RICHMOND COMMUNITY SCHOOL
Richmond High School: Mechanical Modernization Project
LWC Commission No. 20104.02

ADDENDUM #02
September 24, 2021

LWC, Inc.
712 EAST MAIN ST
RICHMOND, IN 47374

Comm. No.	Date
20104.02	06.18.2021
Drawn	Drawing No.
TOD	D203
Checked	KRM

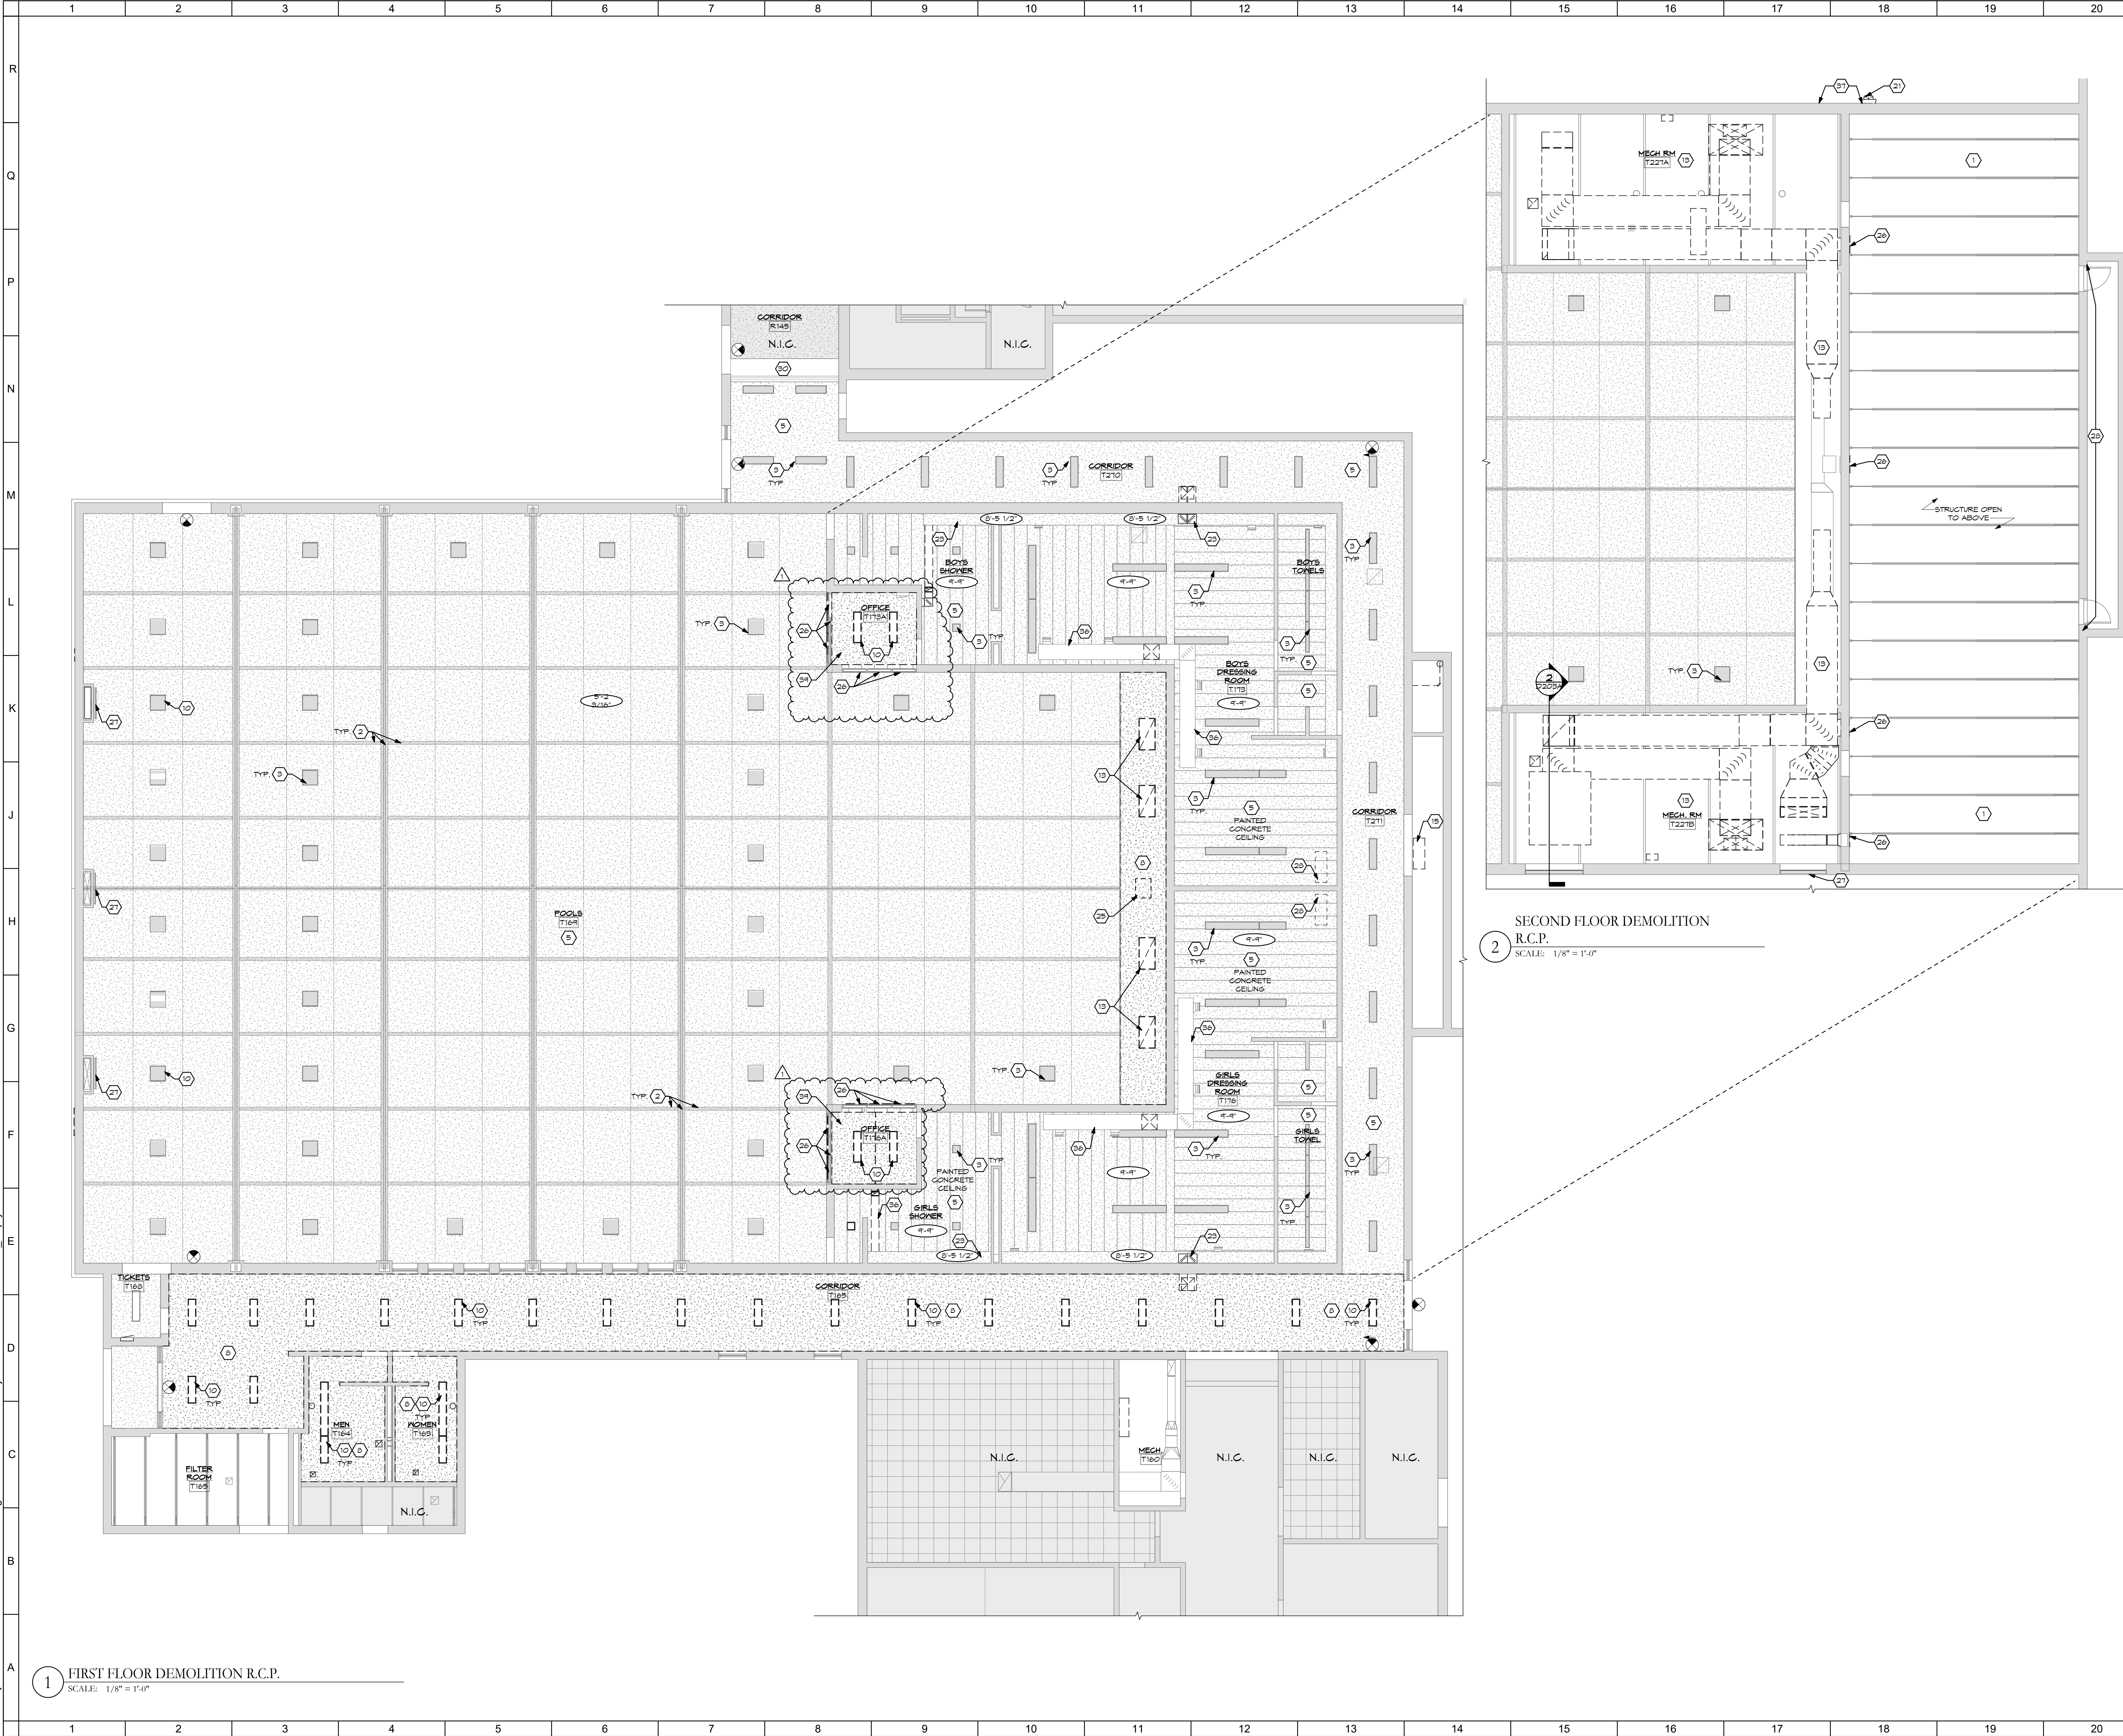
- A. Clarification notes to Office "T173A & T176A" on drawing.

Comm. No.	Date
20104.02	06.18.2021
Drawn	Drawing No.
TOD	A203
Checked	KRM

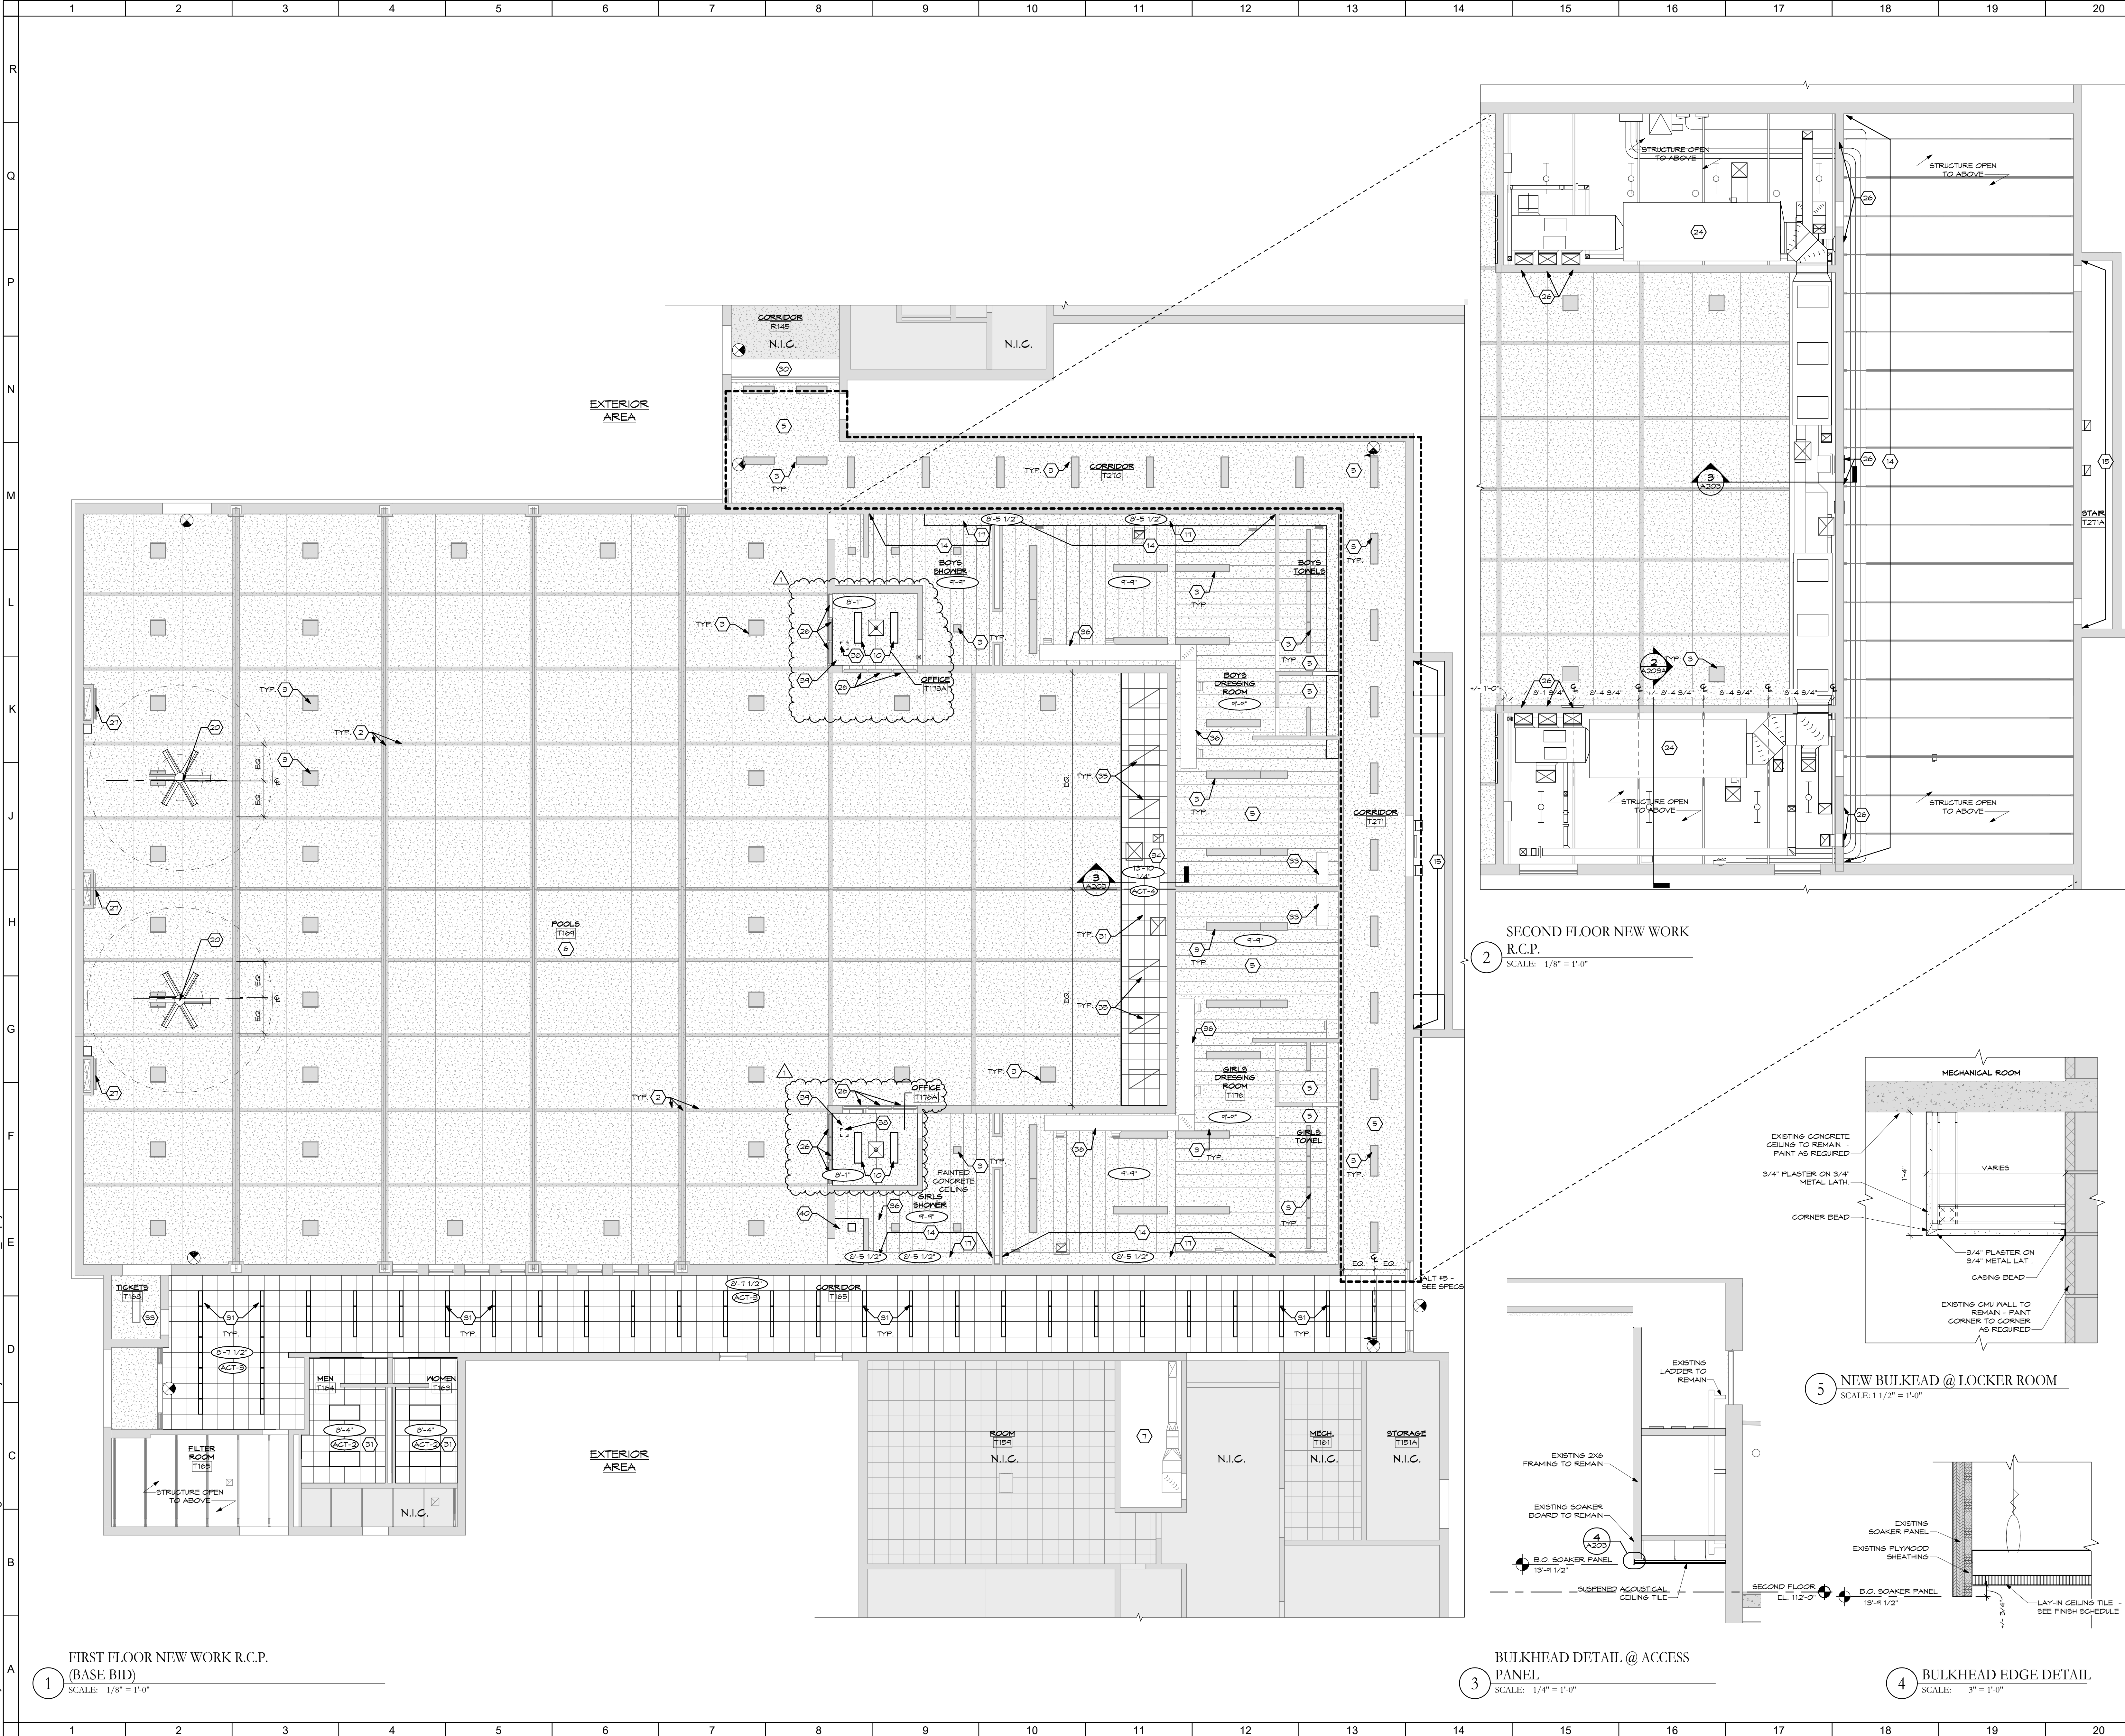
- A. Clarification notes to Office "T173A & T176A" on drawing.

Comm. No.	Date
20104.02	9.10.2021
Drawn	JLK
Checked	NPR
Drawing No.	M203

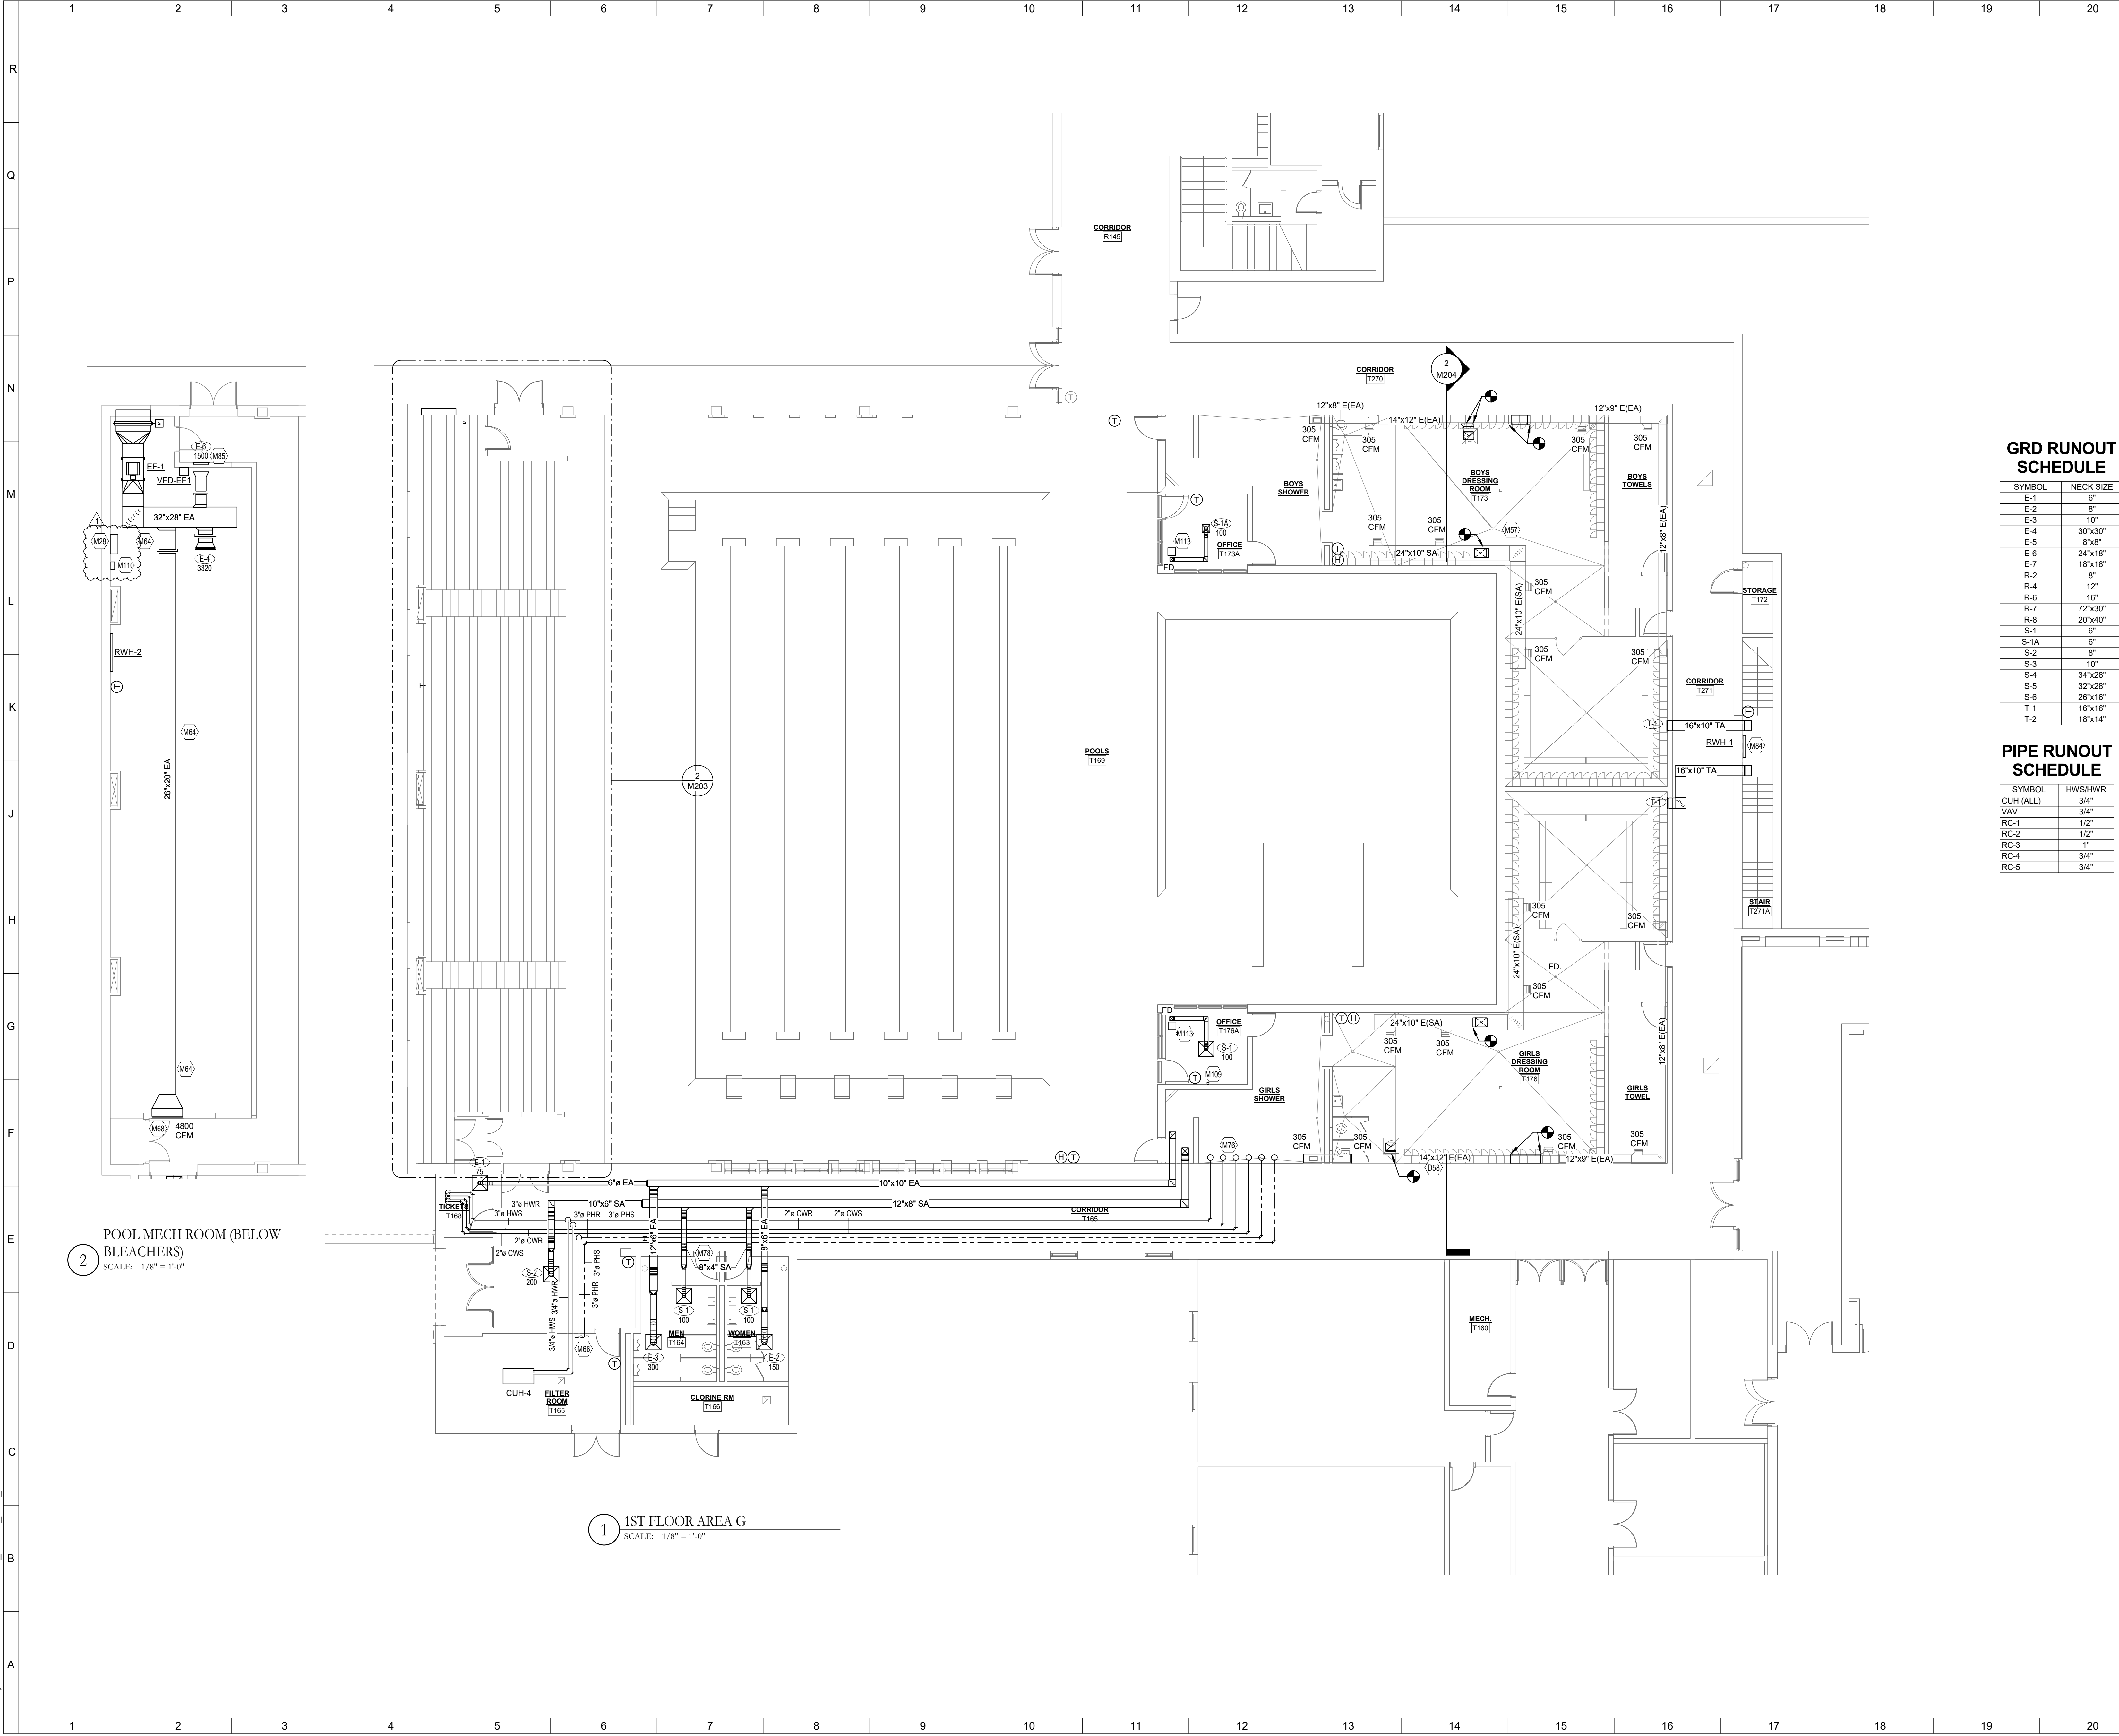
- A. Added BAS panel adjacent to HVLAS fan BACnet controller.
